MEMORANDUM

TO: CHAIRMAN AND MEMBERS OF THE PLANNING COMMISSION
FROM: DIRECTOR OF PLANNING, BUILDING AND CODE ENFORCEMENT
DATE: JULY 22, 2008
SUBJECT: VESTING TENTATIVE TRACT MAP NO. 68796, ET AL. (CASE NOS. SUB2007-00003 & ZON2007-00072); PROPOSED 28-UNIT CONDOMINIUM PROJECT AT 28220 HIGHRIDGE ROAD

TO: KIT FOX, ASSOCIATE PLANNER
FROM: JOANNE ITAGAKI, CONSULTANT TRAFFIC ENGINEER
DATE: July 2, 2008
SUBJECT: DRAFT TRAFFIC IMPACT ANALYSIS FOR 28220 HIGHRIDGE ROAD RESIDENTIAL DEVELOPMENT – June 24, 2008

**Subject: Response to Comments on the Revised Traffic Impact Analysis
for the 28220 Highridge Road Residential Development, City of
Rancho Palos Verdes**

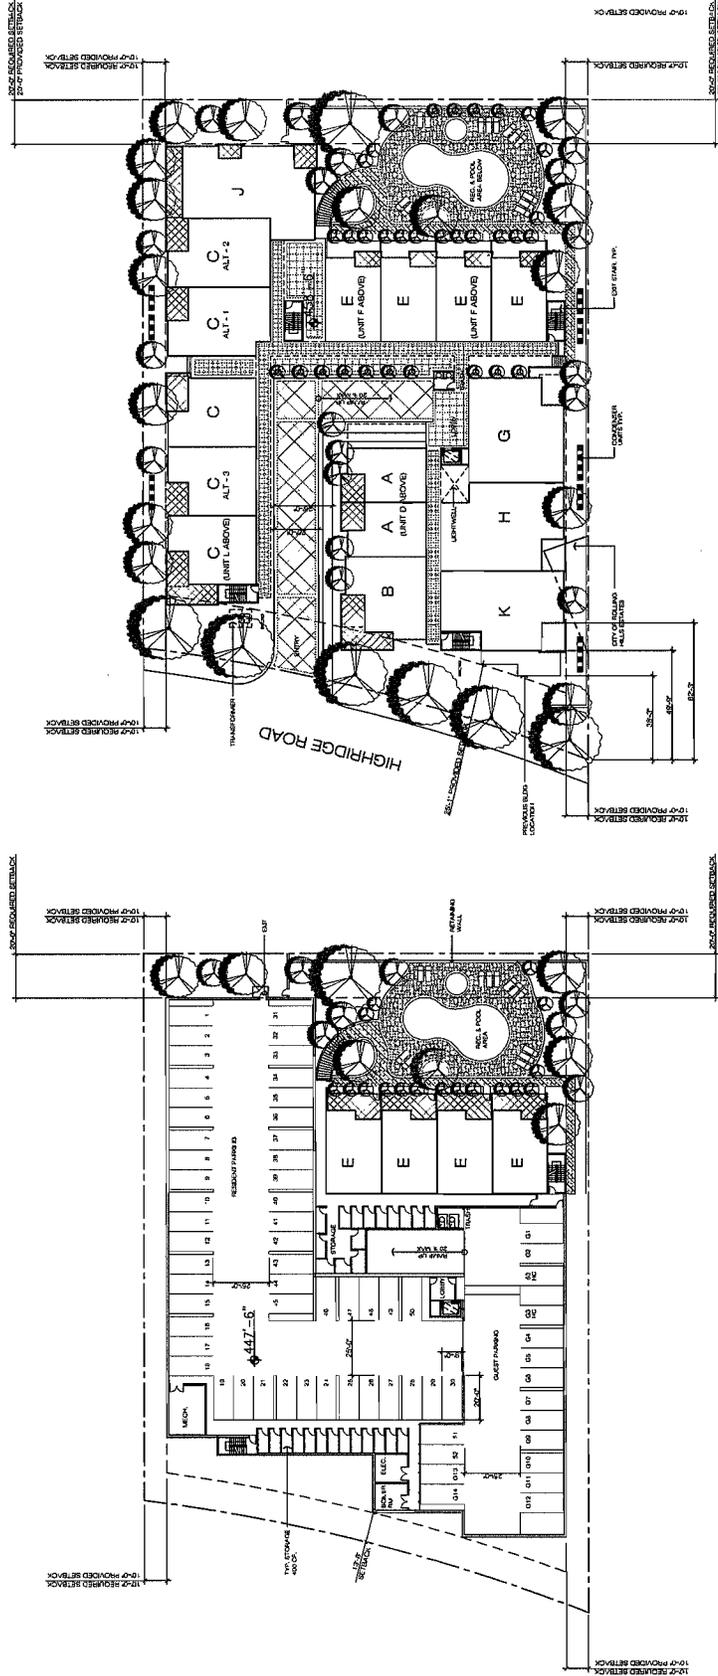
On June 24, 2008, the Planning Commission asked the developer to further explore the feasibility of reducing the view impacts of the project upon the residence at 7 Via La Cima by reconfiguring the site plan to place the pool area at the front of the site and push the buildings further back from the street, possibly placing units in the location of the proposed pool. Staff received an e-mail response from the developer's architect on July 3, 2008 (see attachments). To paraphrase his response:

1. Moving unit K to the rear adjacent or attached to unit J would require 20' - 30' of separation between unit E per the new CBC code table 704.8. Due to this requirement, the new unit would be too small to be functional. It would also be beyond the fire department 150' hose pull length required by code.

2. Moving the pool and entry to the southeast property line adjacent to Highridge, would rise the building elevation by 3'-0" for a podium height of 461.5 and a roof height of 487'. At the rear property line the building height would increase above 36' feet, requiring direct fire department access, and the slope would make it impractical for the fire department due to grade changes, it would also not meet zoning requirements. This also creates fire department and vehicular accessibility issues in regards to life safety. The building occupies the width of the site, and the design would increase the view impact La Cima unit 7.

We have discussed additional revisions to the building plan to reduce impacts to La Cima unit 7 by moving the corner of unit K back 24' to reduce the view impact. Please see the attached revisions to the drawings.

We have done many studies and the site plan proposed to the planning commission on 6/24 is the best solution to minimize the view impacts to the adjacent property. The attached revision will help to minimize the impact to La Cima unit 7.
